Fire Chief Correspondence

RE: Review of 156-160 Wayne Avenue Proposed Site Plan

Subject: Review of 156-160 Wayne Avenue Proposed Site Plan

Re: Wayne Avenue Low Rise Townhouses GML Review Letter

FIGURE D103.1 DEAD-END FIRE APPARATUS ACCESS ROAD TURNAROUND

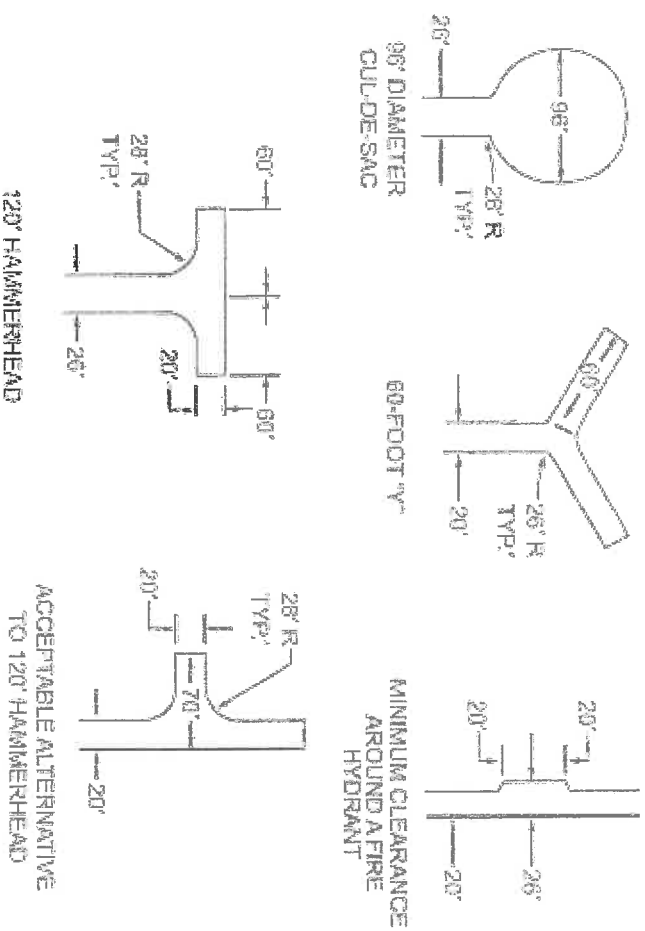
1. The main issue I have with this is that as per the **2020 Fire Code of NYS, section 503.2.5 Dead Ends: Dead-end fire apparatus access roads in excess of 150 feet (45 720 mm) in length shall be provided with an approved area for turning around fire apparatus. Appendix D of the same code, specifically D103 Minimum specifications, D103.4 Dead Ends states: Dead-end fire apparatus access roads in excess of 150 feet (45 720 mm) shall be provided with width and turnaround provisions in accordance with [Table D103.4](#). I have added said table below and highlighted the applicable requirement:**

As you can see from the above, the plan one of the above configurations need to be used.

TURNING RADIUS: 5M100 230" WHEELBASE

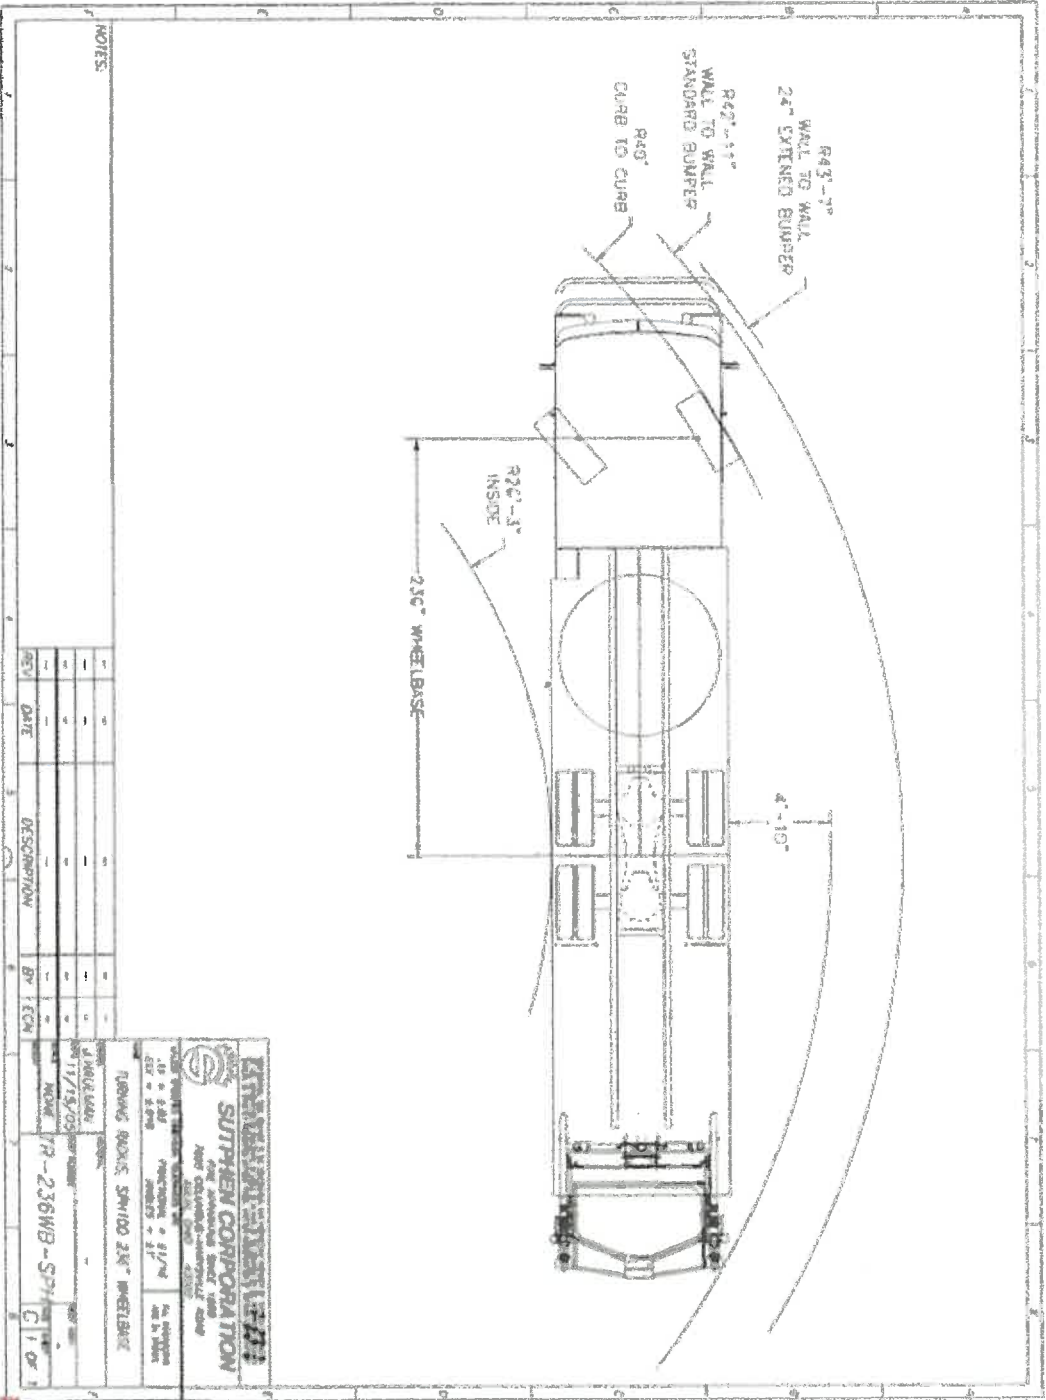
2. I would like to see a "Fire Apparatus Turn Analysis" drawing based on Suffern Fire Department's tower ladder truck "19-Tower". I have attached the specs.
3. Minimum Total side yard is listed as 55. It should say N/A because pursuant to 266-15H of our code, this proposal has 2 front yards, one rear yard and only one side yard.
4. I would like to confirm that the plan has now changed so that each unit now has a separate basement AND that each basement, which is now listed as "Storage" is indeed planned as non-habitable space i.e. laundry, mechanical room, storage uses only.
